COUNCIL ASSESSMENT REPORT

Panel Reference	2016SYE113
DA Number	DA0176/2016
LGA	Northern Beaches Council
Proposed Development	Construction of a mixed-use development and alterations to the existing Auckland Garage building, comprising a registered club at ground level and residential accommodation above, basement car parking, associated landscaping and strata subdivision
Street Address	2 West Promenade, Manly
Applicant/Owner	Applicant: Robinson Urban Planning Owner: Manly Civic Club
Date of DA lodgement	1 July 2016
Number of Submissions	29
Recommendation	Approval
Regional Development Criteria (Schedule 4A of the EP&A Act)	Schedule 4A (3) – the development has a capital investment value of more than \$20 million
List of all relevant s79C(1)(a) matters	<ul style="list-style-type: none"> • Manly Local Environmental Plan 2013 • State Environmental Planning Policy No 65—Design Quality of Residential Apartment Development (SEPP 65) (and Apartment Design Guide) • Sydney Regional Environmental Plan (Sydney Harbour Catchment) 2005 • Manly Development Control Plan 2013 • Environmental Planning and Assessment Regulation 2000

Development Assessment Report

DA #	176/2016
Site Address	2 West Pr

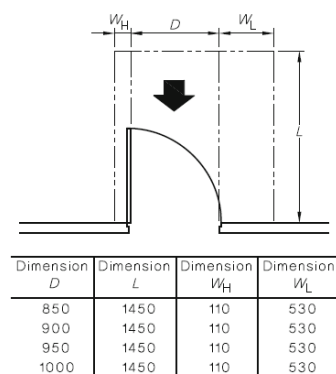
The toilets shown on the plans do not have accessible or ambulant sanitary compartments. A single accessible WC is indicated in the heritage bistro area on its own. An accessible unisex toilet is required at any bank of sanitary amenities containing male and female sanitary compartments in accordance with Premises Standards Table F2.4 (a) and the AS1428.1. An ambulant toilet is also required for a use by males or females. The layout have to be reconfigured according to the BCA and Premises Standards.

Suitable conditions have been applied, including conditions to ensure compliance with the Building Code of Australia. The applicant has provided amended plans demonstrating a compliant number of adaptable units. Parking provision is considered acceptable for the reasons detailed in the section of this report relating to the Apartment Design Guide – Universal Design.
